UNITED STATES PATENT AND TRADEMARK OFFICE

APPLICATION NO.	FILING DATE	FIRST NAMED INVENTOR	ATTORNEY DOCKET NO.	CONFIRMATION NO	
10/718,466	11/19/2003	Teng-Chun Tsai	JCLA11486	1034	
759	09/20/2004		EXAM	EXAMINER	
J.C. Patents, In	c.		NGUYEN, GEOR	NGUYEN, GEORGE BINH MINH	
Suite 250 4 Venture			ART UNIT	PAPER NUMBER	
Irvine, CA 926	518		3723		
			DATE MAILED: 09/20/200	DATE MAILED: 09/20/2004

DETAILED ACTION

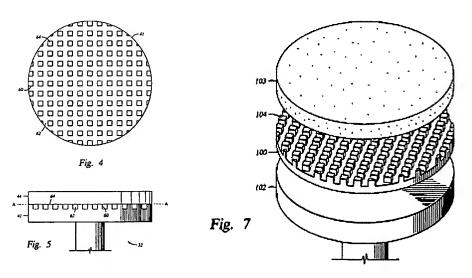
- (b) the invention was patented or described in a printed publication in this or a foreign country or in public use or on sale in this country, more than one year prior to the date of application for patent in the United States.
- 3. Claims 1, 2, 6, 8, 11-16 are rejected under 35 U.S.C. 102(b) as being anticipated by Tolles et al.'6,220.942.

With reference to Figures 4, 5, and 7, Tolles discloses the claimed invention.

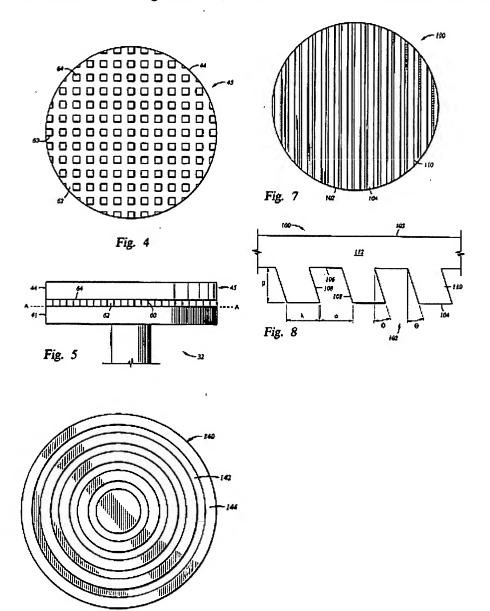
4. Claims 18-20 are rejected under 35 U.S.C. 102(b) as being anticipated by Tolles et al.'6,217,426.

With reference to Figures 4, 5, 7, 9, and 11, Tolles discloses the claimed invention.
